Car Stereo  
Service Bulletin

**Model:** EX-R400, XR-300

**No. 167**

**Subject:** Flashing Display

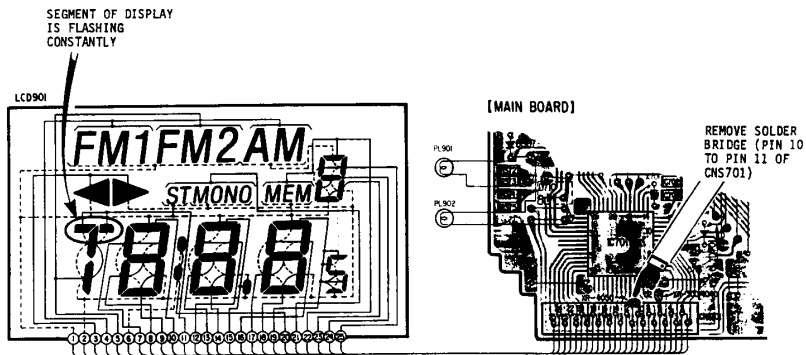
**Symptom:**  
(13)

Segment of display is flashing constantly.

**Solution:** Remove solder bridge on Pins 10 and 11 of CNS701.
